Access Compliance Report

Public Rights-of-Way

Intersection ID: 49391	Main Street: GELBRAY_CT	Cross Street: AUBRAC_LN	Location: NW
ADA ID: 5E7C9304AC0A	Ramp Type: BlendTrans1	Initial Pass/Fail: Fail	Overall Compliance: No
		Severity Score: 10

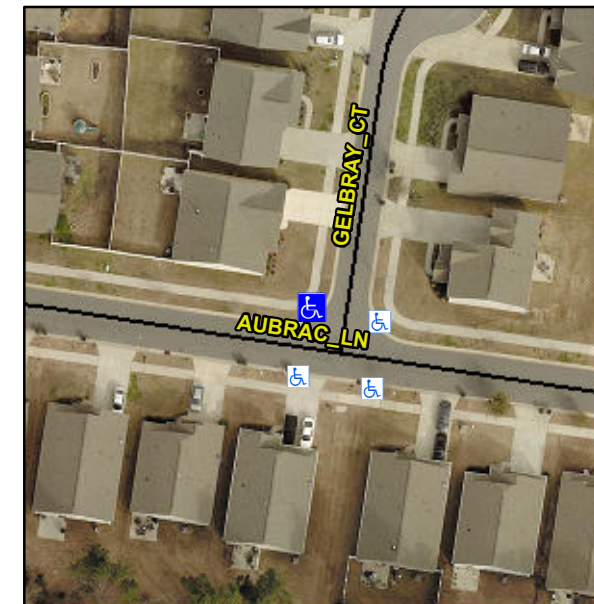
CURB WIDTH 45.0, DWS LIP 1.0

Not Found, R304.5.1, R304.5.3

Compliance	Description	Data	Compliance	Description	Data
N/A	Ramp Length (in)	70.5	Yes	BlendTrans Slope (%)	3.2
No	Ramp Width (in)	47.0	No	BlendTrans XSlope (%)	2.1
N/A	Flare Type LT	N/A	N/A	Flare Type RT	N/A
N/A	Flare Slope LT (%)	N/A	N/A	Flare Slope RT (%)	N/A
N/A	Flare Traversable LT?	N/A	N/A	Flare Traversable RT?	N/A
N/A	Landing Length (in)	N/A	N/A	DWS Provided?	N/A
N/A	Landing Width (in)	N/A	N/A	DWS Contrast?	N/A
N/A	Landing Slope (%)	N/A	N/A	DWS Length (in)	N/A
N/A	Landing X Slope (%)	N/A	N/A	DWS Full Width?	N/A
N/A	Landing Curb? (Y/N)	N/A	N/A	DWS Offset (in)	N/A
N/A	Shared Landing?	N/A			
N/A	Gutter Ponding?	N/A	N/A	Gutter Slope (%)	N/A
N/A	Gutter Lip Ht (in)	N/A	N/A	Gutter X Slope (%)	N/A
N/A	Painted X Walk1?	No	N/A	Painted X Walk2?	No
	X Walk 1 Direction	To SW		X Walk 2 Direction	To E
	X Walk 1 Width (in)	N/A		X Walk 2 Width (in)	N/A
	X Walk 1 Slope (%)	2.2		X Walk 2 Slope (%)	1.3
	X Walk 1 X Slope (%)	2.6		X Walk 2 X Slope (%)	3.3

N/A	Ramp inside XWalk1?	N/A	N/A	Ramp inside XWalk2?	N/A
	Road Slope (%)	2.3		Clear Space?	N/A
	Road X Slope (%)	0.5	N/A	Clear Space to XWalk (in)	N/A
N/A	Any Obstructions?	N/A	N/A	Storm Grate/Utility Hazard?	N/A
	Obstruction Type			Storm Grate/Utility Type	
		N/A			N/A
			Yes	Surface Condition? (G/P)	Good
			No	Curb Slope (%)	19.6

Remove & Replace Curb Ramp With Two New Directional Ramps or Equivalent.
